Sundry Print Report

Well Name: CARSON UNIT 11

Type of Action Plug and Abandonment

BLM FLUID MINERALS
Geologic Report

Proposed Wellbore Diagram

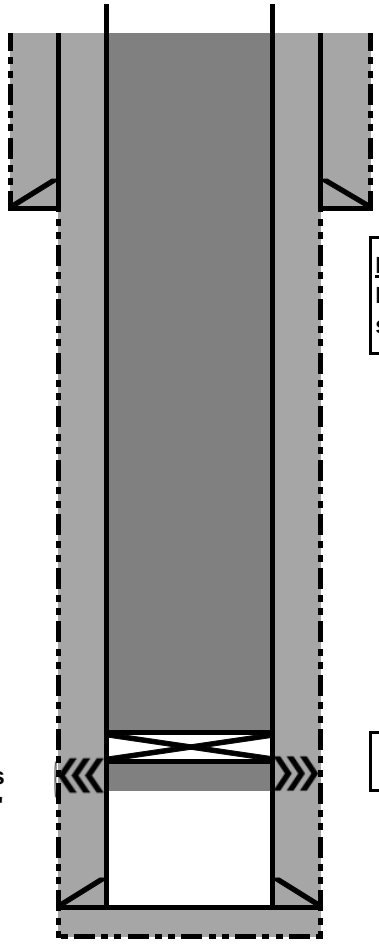
- No well log available for the subject well.
- BLM formation top estimates vary from operator picks. No change to the P&A procedure is required (entire well bore will be cemented to surface).
- Log analysis of reference well #2 indicates the Nacimiento and Ojo Alamo sands investigated likely contain fresh water (≤5,000 ppm TDS). P&A procedure has cement from the cement retainer @ 1050’ to Surface which will protect freshwater sands in this well bore.
- Fruitland Coal perforations @ 1094’-1192’.
